AGENDA

President and Board of Trustees
Village of Arlington Heights
Board Room

April 4, 2016

511 W Rand Memory Care

SHEET NO.
A1.0

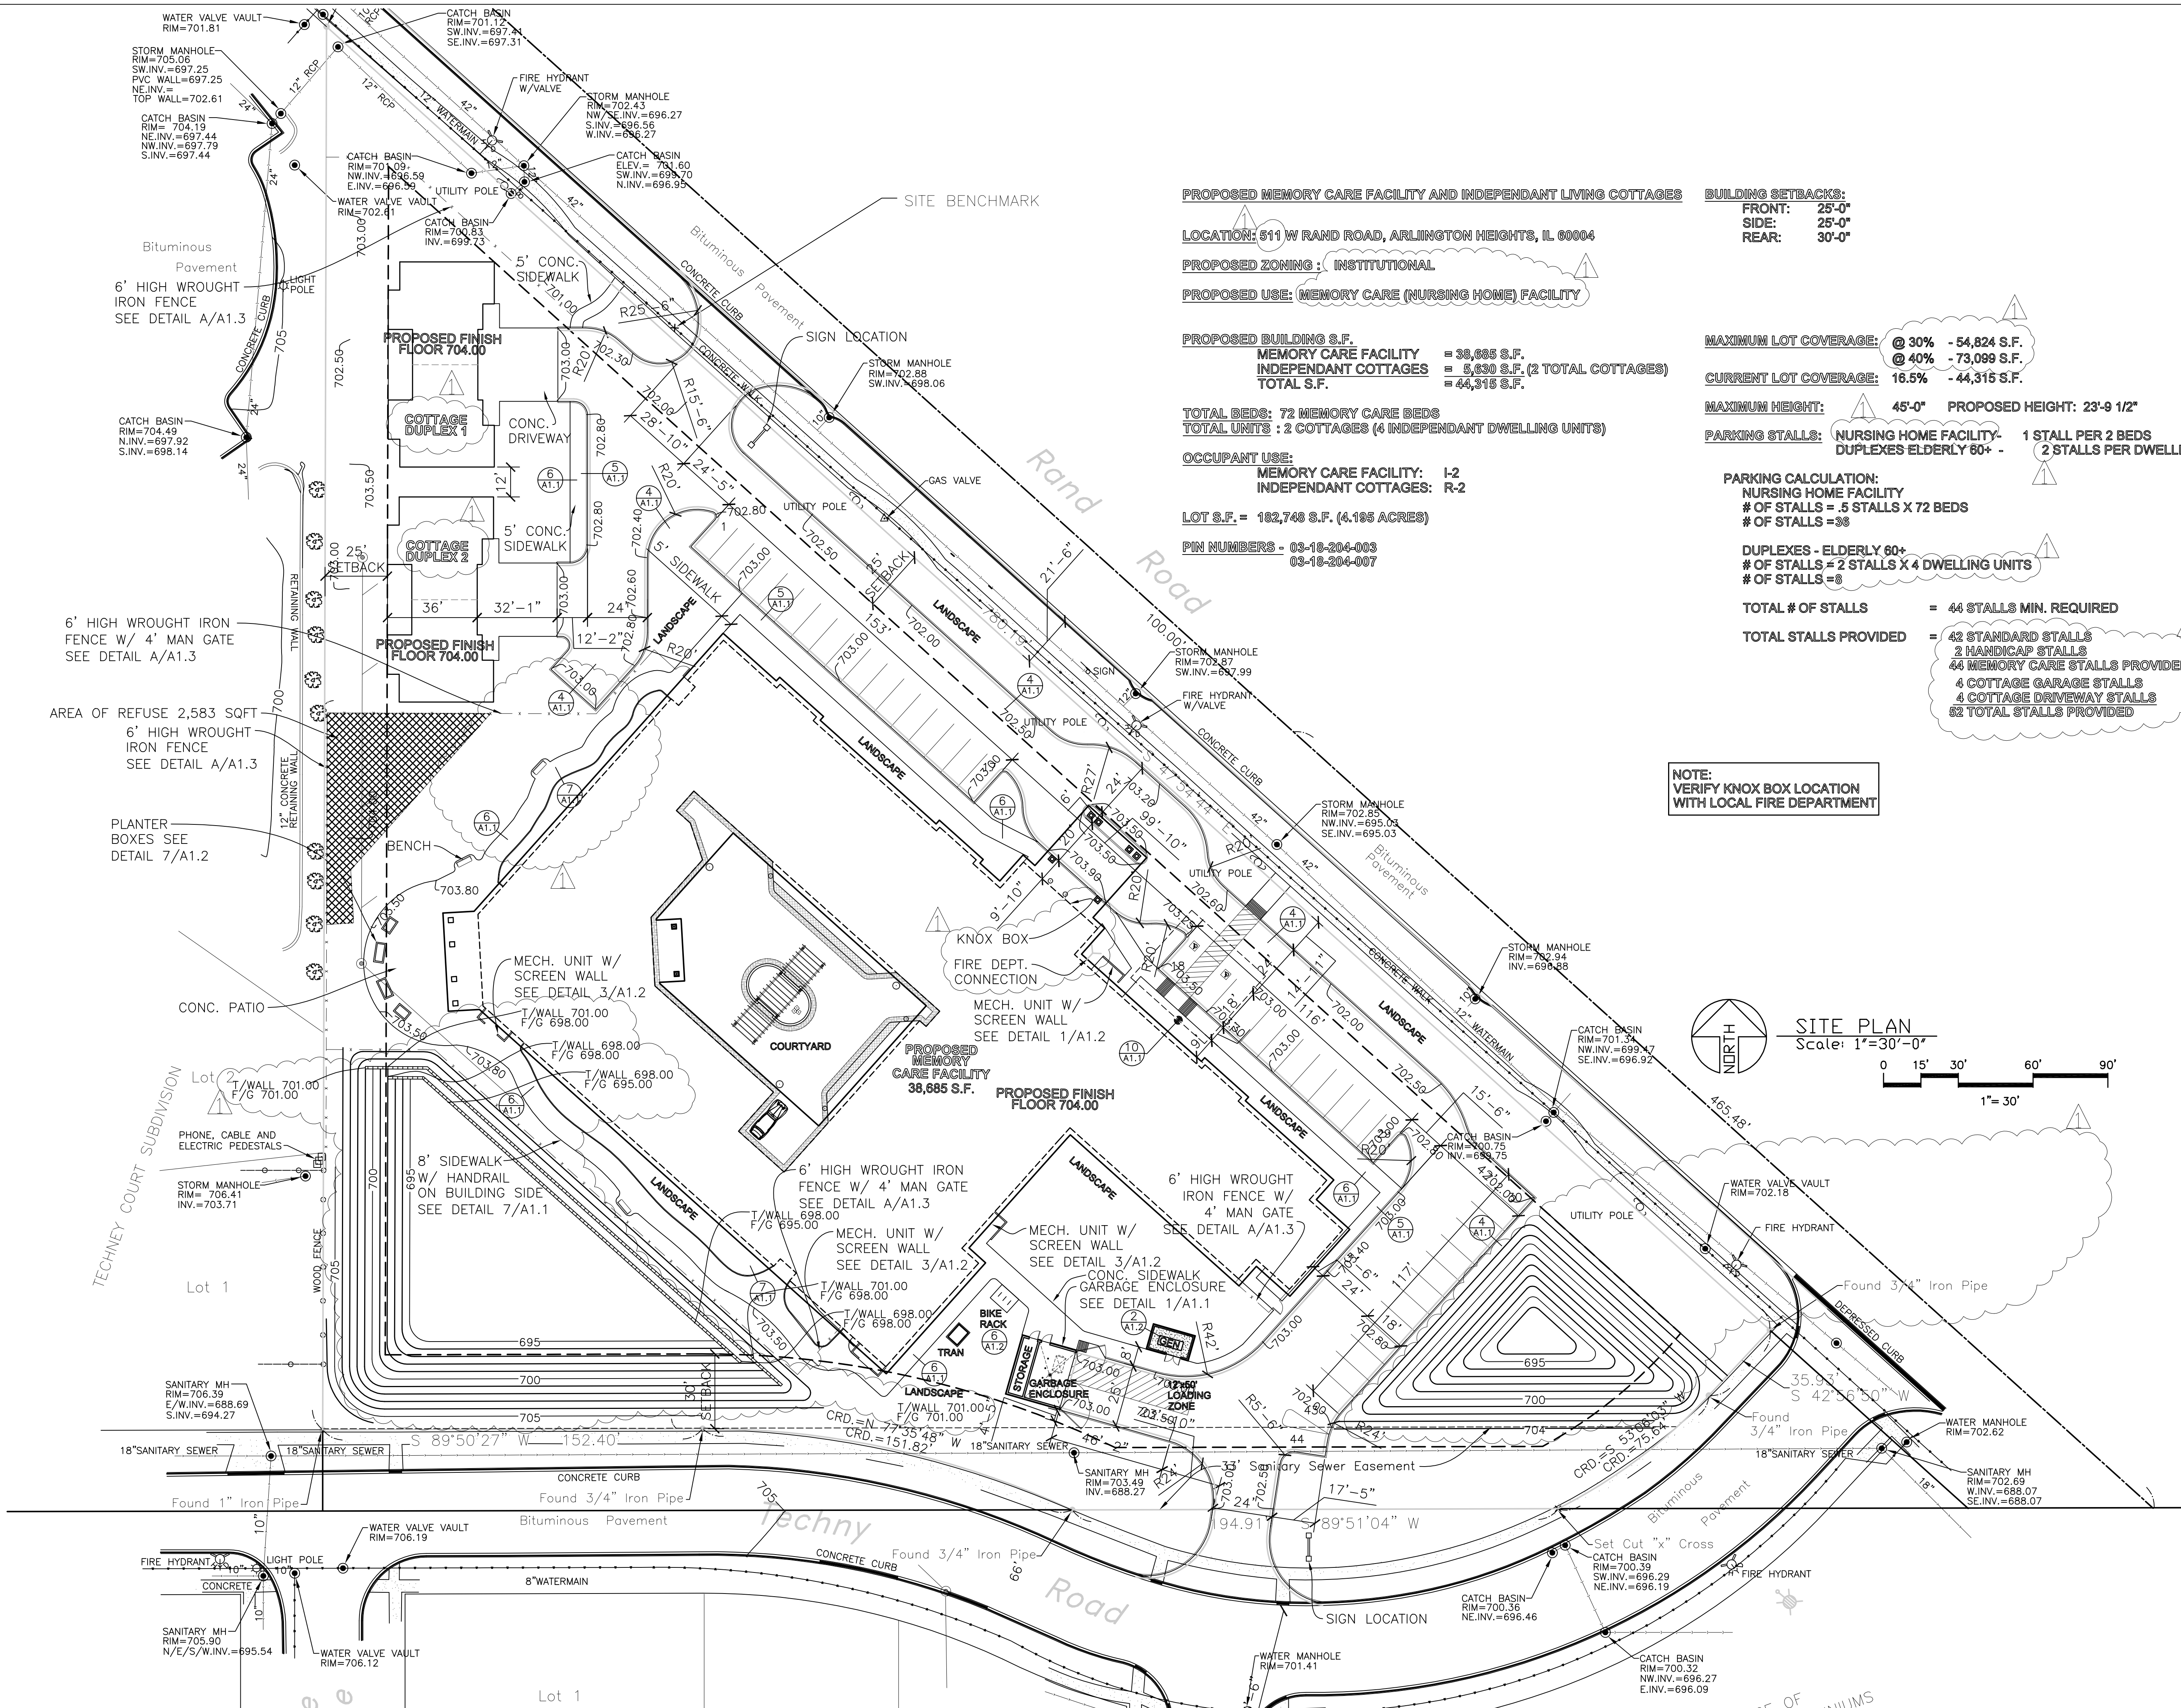
1. Please update the zoning Data on the Site Plan Sheet A1.0: the address is 511 W Rand Road; Proposed Zoning is Institutional; Proposed Use is Memory Care (Nursing Home) permitted in Institutional Zone; Parking Calculation is for Nursing Home not Human Services.

5. What is the "are of refuse" at west end of site plan as indicated on Site Plan sheet A1.0?

7. Provide details and elevations for garbage/storage enclosure (site plan references "Detail A1.1" but that detail was not submitted with Plan Commission application), as well as the Generator.

Sheet A1.0 has been revised to show updated zoning data, address, proposed use and parking requirements.

Sheet A1.1 will be submitted separately from this submittal, within the next few days, and will show these items as requested.

Sheet A1.0 has been revised to show the retaining wall in the west detention basin. The wall will be screened with landscaping. The 6 foot high retaining wall has been revised to (2) 3 foot retaining walls.

LP-2

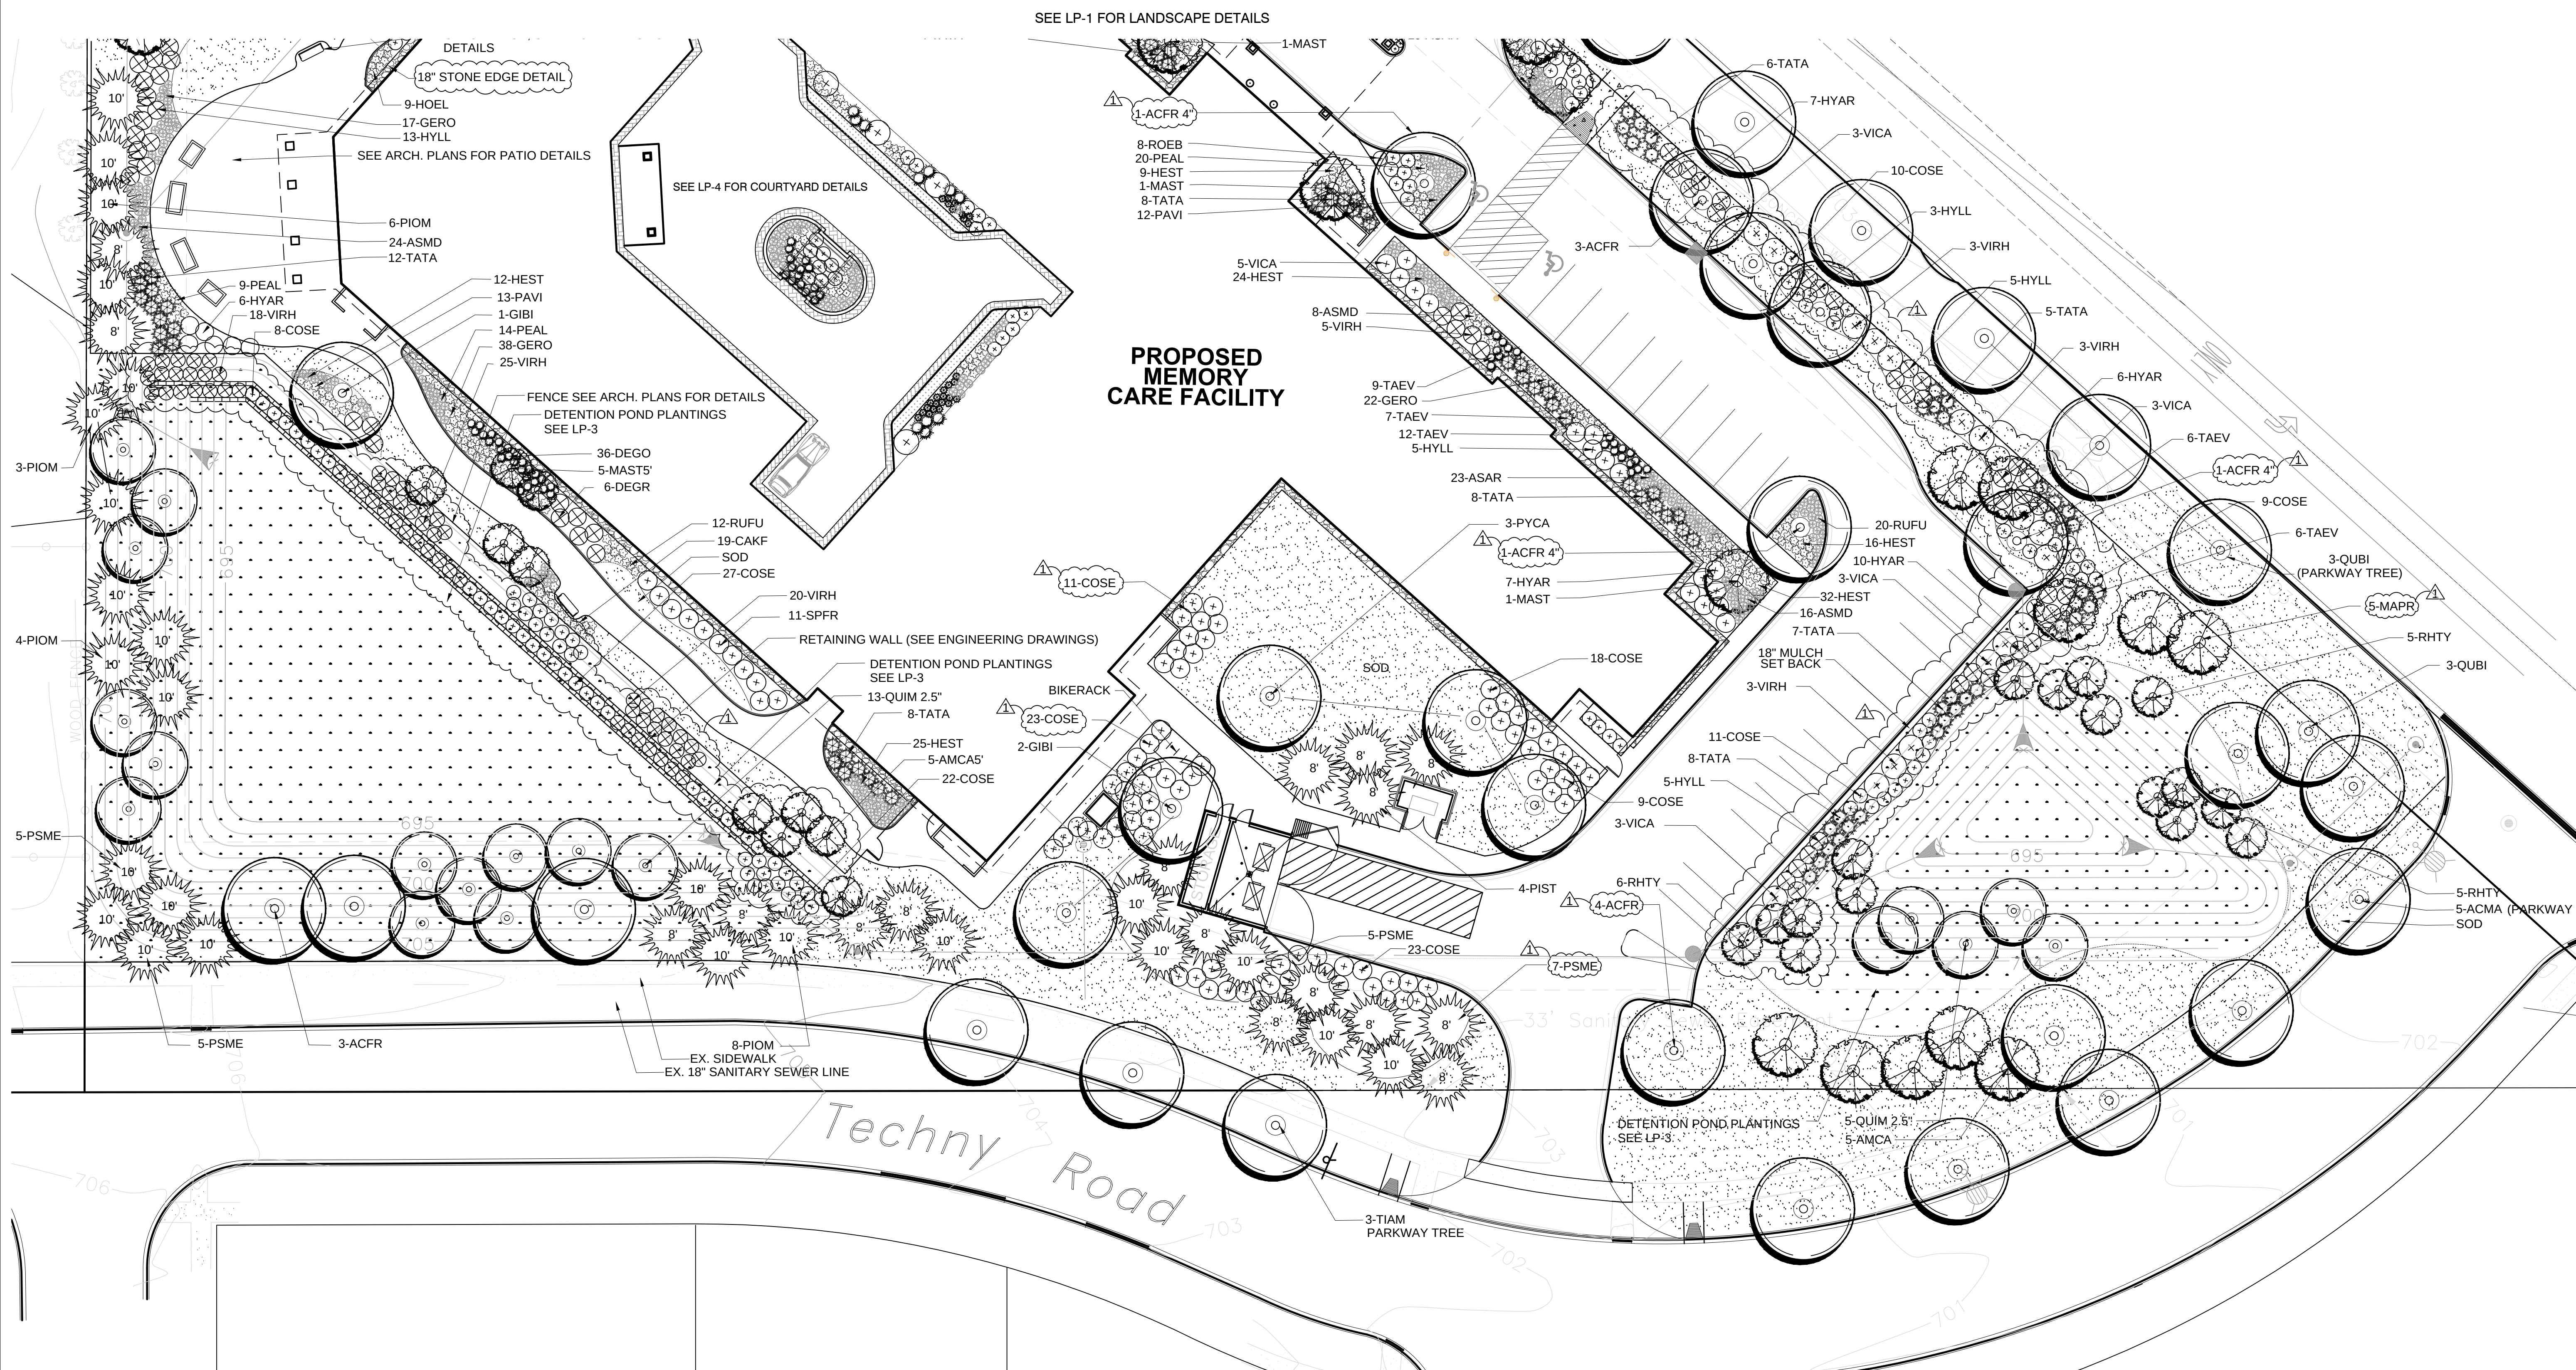
3. Must provide additional landscaping along the west property line adjacent to the residential district. Incorporate a mix of evergreens in order to create a continuous 6 foot high screen.

Deciduous shrubs have been added where possible to screen the transformer. Please see Sheet LP-2 for locations.

Trees located at the end parking islands have been increased to 4" in caliper size. Refer to the revised Plant list located on Sheet LP-2 for information.

Three Douglas Fir trees have been added to the plans. Please see Sheet LP-2 for locations.
